**SOLICITATION AMENDMENT  
MODIFICATION DE L'INVITATION**

<b>Title - Sujet</b> HVAC Upgrade	
<b>Solicitation No. - N° de l'invitation</b> F1700-164101/A	<b>Amendment No. - N° modif.</b> 003
<b>Client Reference No. - N° de référence du client</b> F1700-164101	<b>Date</b> 2017-04-03
<b>GETS Reference No. - N° de référence de SEAG</b> PW-\$PWY-026-8013	
<b>File No. - N° de dossier</b> PWY-6-39353 (026)	<b>CCC No./N° CCC - FMS No./N° VME</b>
<b>Solicitation Closes - L'invitation prend fin</b> <b>at - à 02:00 PM</b> <b>on - le 2017-04-13</b>	
<b>F.O.B. - F.A.B.</b> <b>Plant-Usine:</b> <input type="checkbox"/> <b>Destination:</b> <input checked="" type="checkbox"/> <b>Other-Autre:</b> <input type="checkbox"/>	
<b>Address Enquiries to: - Adresser toutes questions à:</b> Yi (PWY), Patty	<b>Buyer Id - Id de l'acheteur</b> pwy026
<b>Telephone No. - N° de téléphone</b> (778) 919-2578 ( )	<b>FAX No. - N° de FAX</b> (604) 775-6633
<b>Destination - of Goods, Services, and Construction:</b> <b>Destination - des biens, services et construction:</b> DFO - Pacific Biological Station - Nanaimo, BC

**Amendment 003 has been raised to incorporate questions and answers and Drawing F03**

Freedom  
Series 2100  
Motor Control

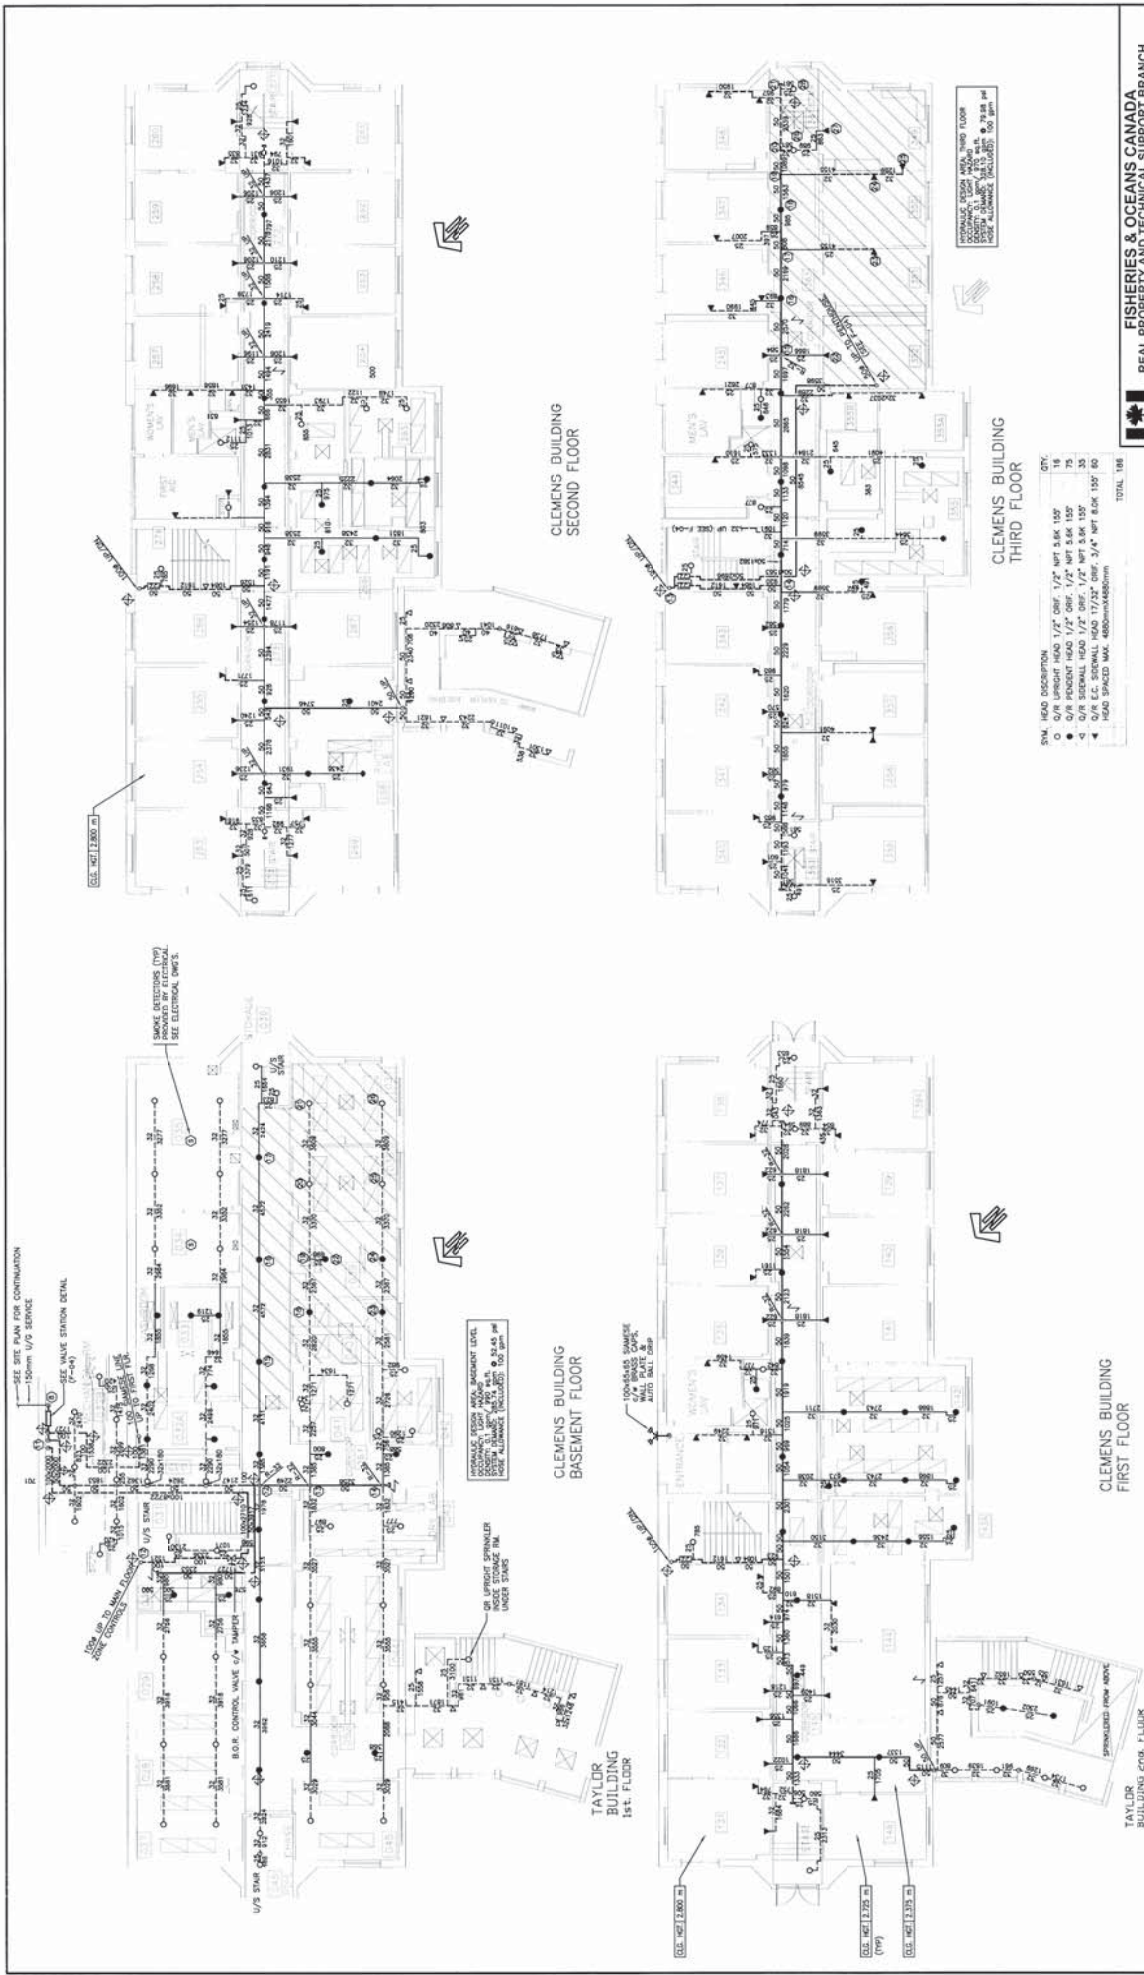
- 6) *We are looking for more information on some of the electrical equipment involved in this project, specifically the MCC shown on electrical drawing E-1. We are looking for info (best case a photo) from the name plate on the MCC to provide to the suppliers. They require this to price the correct equipment. I have spoken to the consultants and they don't have any further information. Is there a person at the PBS that could provide this information, or meet me on site so I could look myself?*

See Attached Photo of the MCC name plate.
